Rezoning Transportation Analysis

Petition Number: 2020-099
General Location Identifier: 04705303

Outstanding Issues

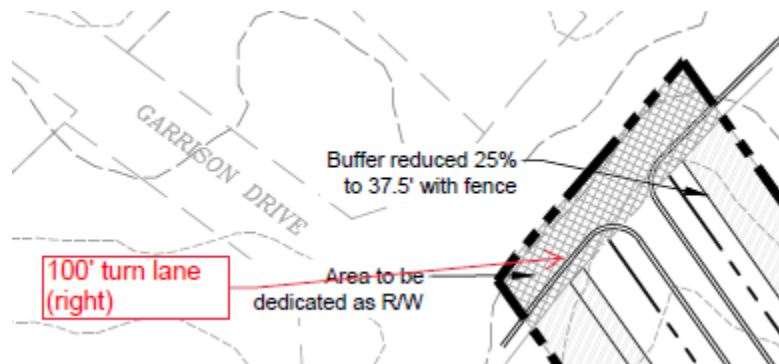
3. The petitioner should revise the site plan to include the roadway improvements that will be constructed within NCDOT's STIP (#U-2507A). In accordance with Charlotte BIKES, please provide an 8-ft planting strip and a 12-ft multi-use path, if sidewalk is not constructed within the STIP.
4. The petitioner should revise the site plan and conditional note(s) to confirm adequate intersection sight distance, according to CDOT's Sight Distance Policy, for access proposed on Mallard Creek Road.
5. CDOT requests the petitioner revise the site plan and conditional note(s) to provide rear alleys for access to public streets.
6. The petitioner should revise the site plan and conditional note(s) to restrict the proposed access on Mallard Creek Road to a right-in/right-out, with right-turn lane (100-ft storage with appropriate bay taper) on Mallard Creek Road at the proposed access location.

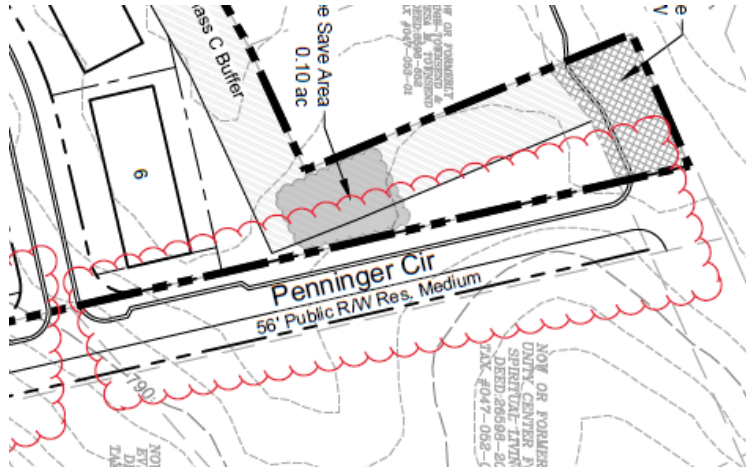
- The petitioner should revise the site plan to add a note specifying dedication and fee simple conveyance of all rights of way to the City before the site's first building certificate of occupancy is issued. CDOT requests right of way set at 2' behind back of sidewalk where feasible.
- The petitioner should remove the proposed access on Mallard Creek Road, as shown below; NCDOT does not support an access at this location of Mallard Creek Road, in reference to the STIP's u-turn bulb-out. Please revise the site plan to provide adequate access for the existing single-family properties, using the proposed USDG Residential Medium/Wide section as proposed below. Please include sidewalk and planting strip on both sides of Penninger Circle.
